**REPORT TO THE SUBDIVISION AND
DEVELOPMENT APPEAL BOARD**

DATE: May 12, 2026	APPEAL NO.: SDAB2026-0057 FILE NO.: DP2025-06980
APPEAL BY: Kathy Tsang	
FROM A DECISION OF THE DEVELOPMENT AUTHORITY where a New: Rowhouse Building (1 building), Semi-detached Dwelling (1 building), Secondary Suite (5 suites), Accessory Residential Building (garage) was approved at <u>2011 20 Avenue NW.</u>	LAND USE DESIGNATION: R-CG Discretionary
COMMUNITY OF: Banff Trail	DATE OF DECISION: March 20, 2026
APPLICANT: CENTRE WEST DESIGN STUDIO	OWNER: Li-Yen Wang

1 **STREETSCAPE**
 A1 SCALE = 1:200

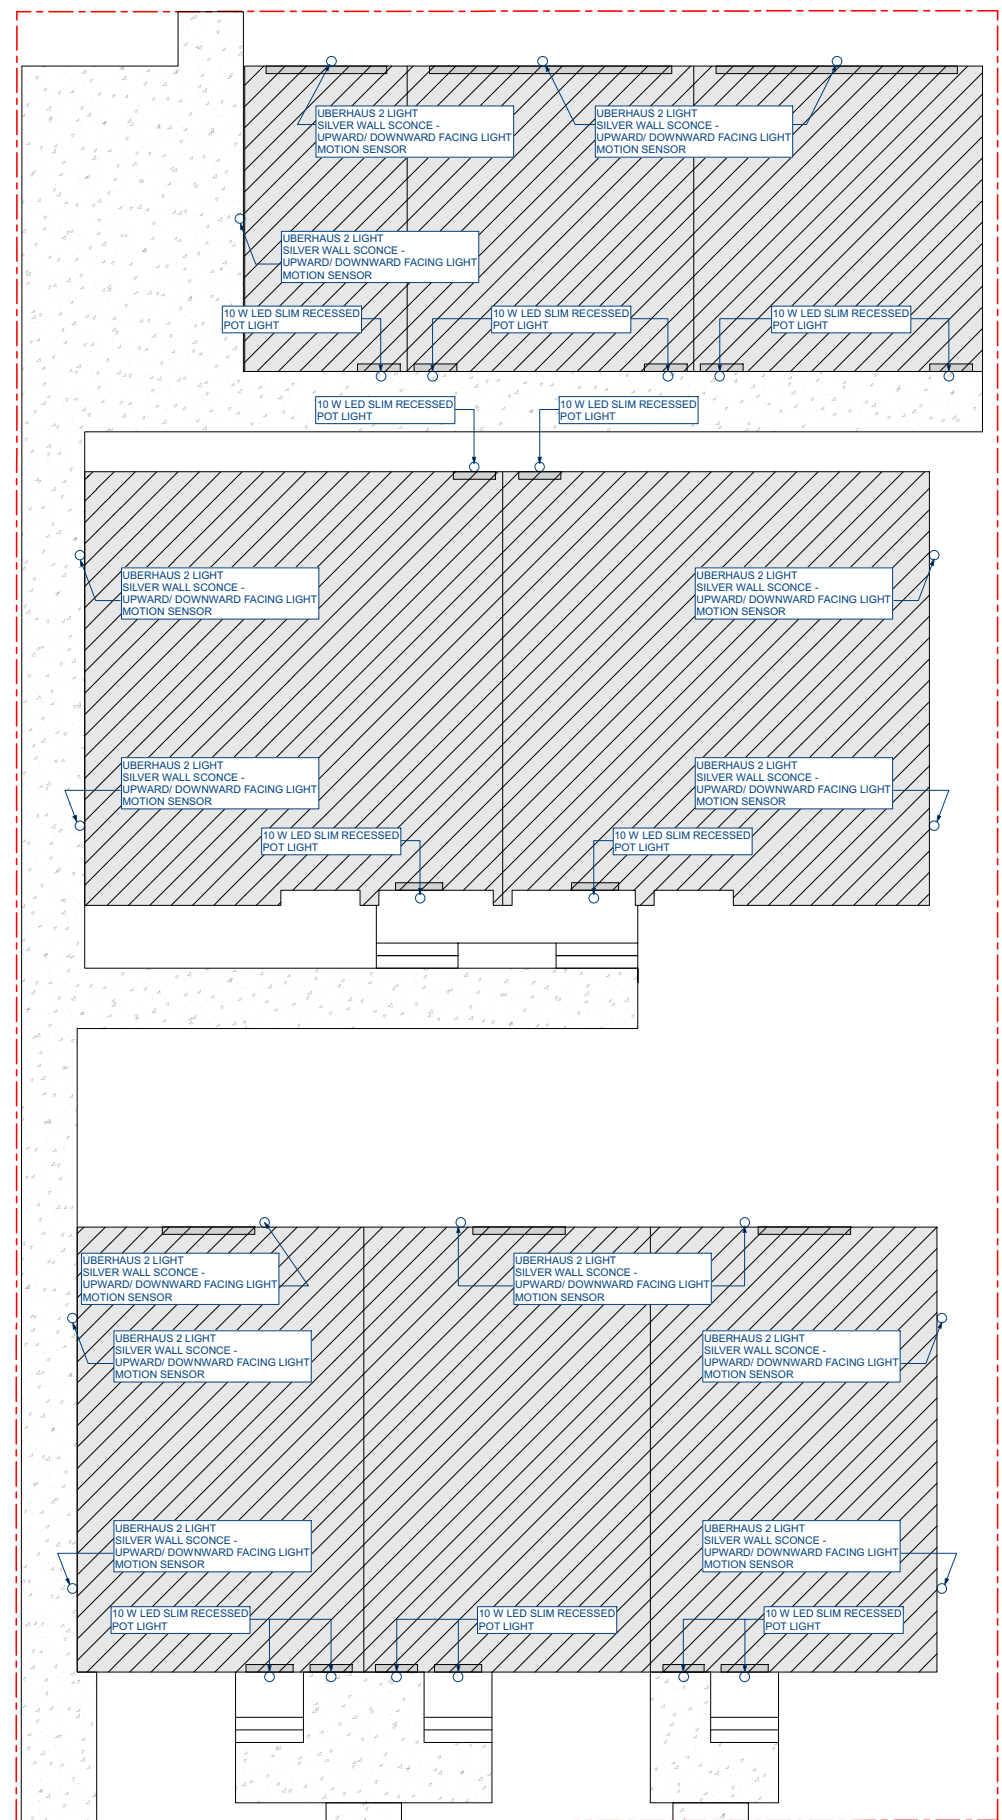
The front building, at 11 metres, is the tallest structure on the block. You can see this clearly on the applicant's own streetscape drawing (Sheet A1), which shows every other building on the block is noticeably shorter. But it is the rear building, sitting in the middle of the block between the houses and the lane, that will most directly cut off western sun to adjacent backyards. This building did not exist in the neighbourhood before. It introduces a wall where there was open sky.

SHEET TITLE:
SITE PLAN / LANDSCAPE PLAN

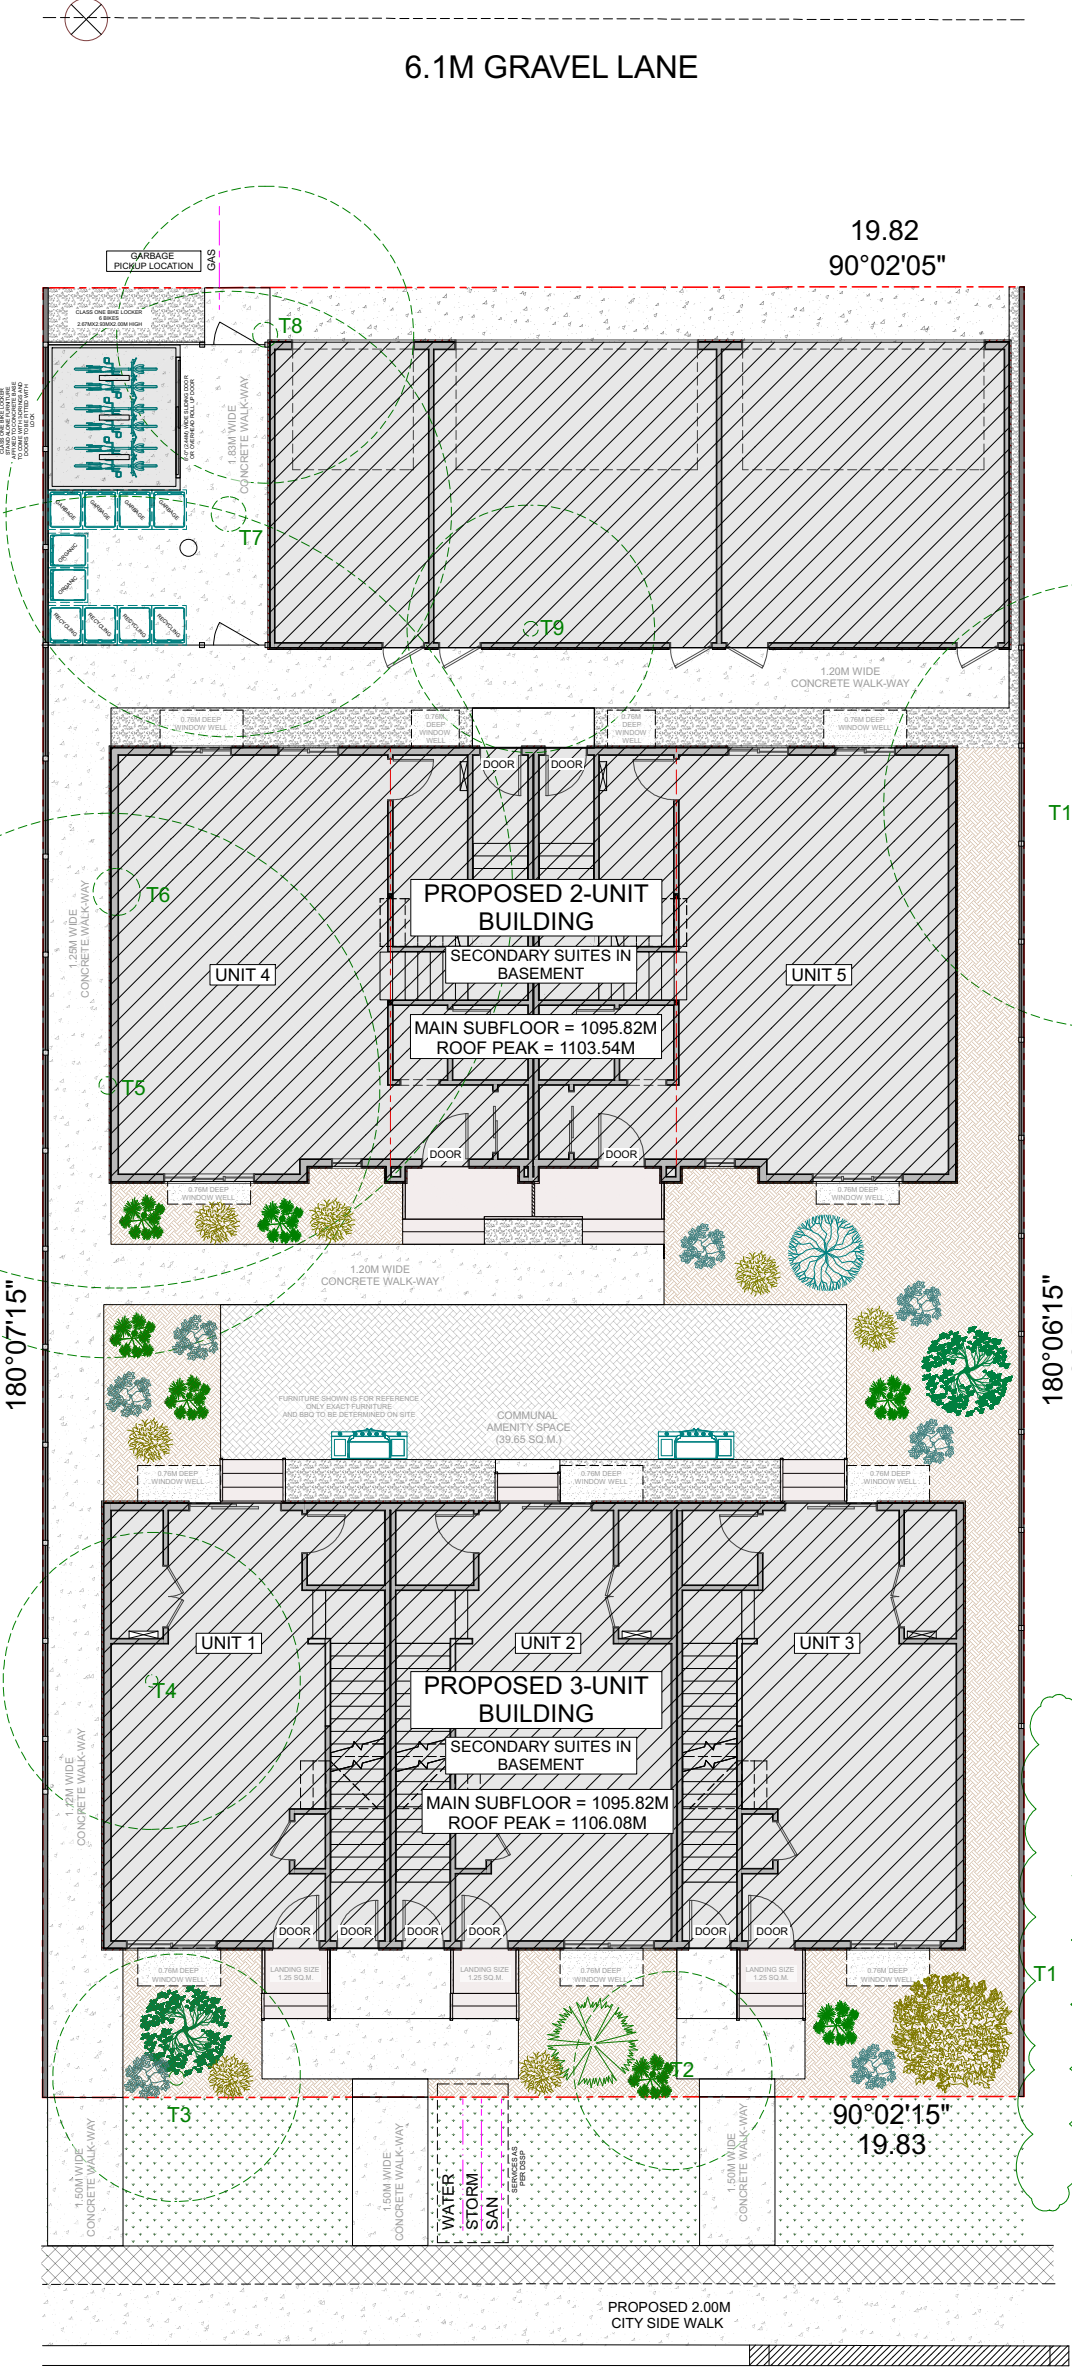
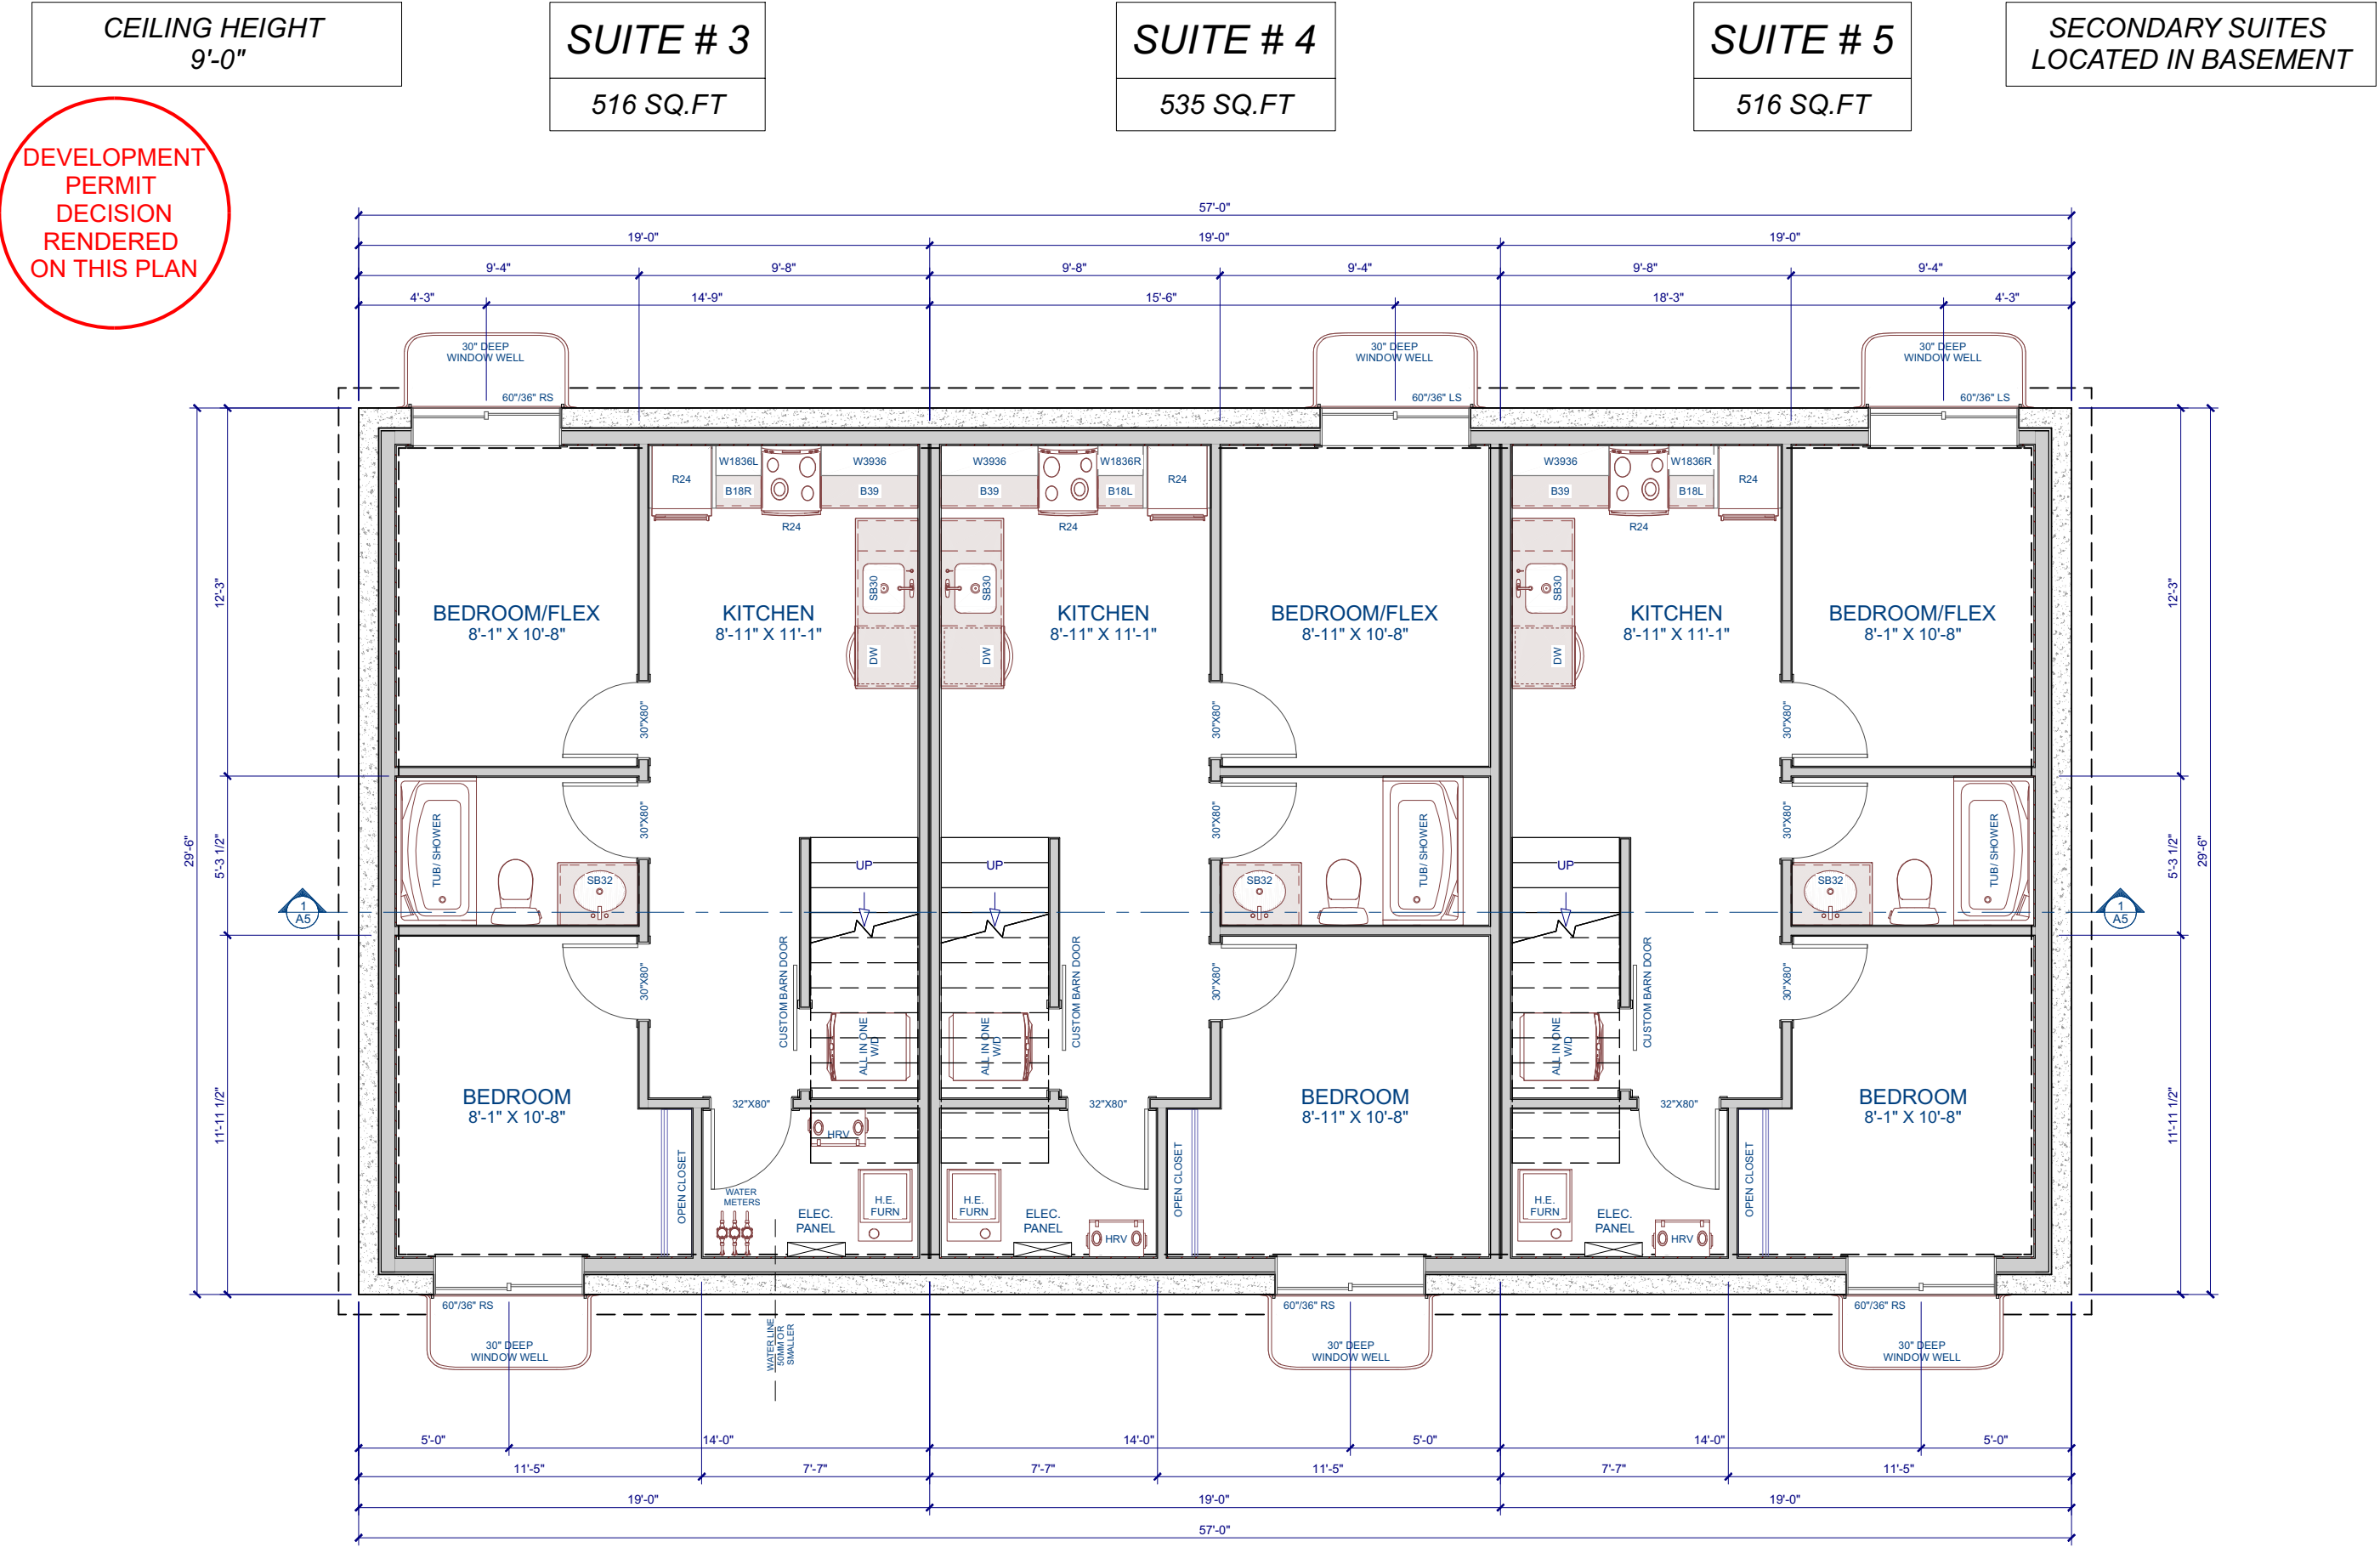
The amended site plan (Sheet A2) shows the development falls short of the required landscape area by about 9 square metres — a deficiency stated on the applicant's own drawings. Every existing tree on the development site is being removed. The Tree Schedule on Sheet A2 lists ten trees; the only two marked "retain" are on adjacent properties, not on the development site itself. There is zero sodded area planned — all the soft landscaping is mulch. On a block with mature trees and grassed yards, this is a stark contrast.
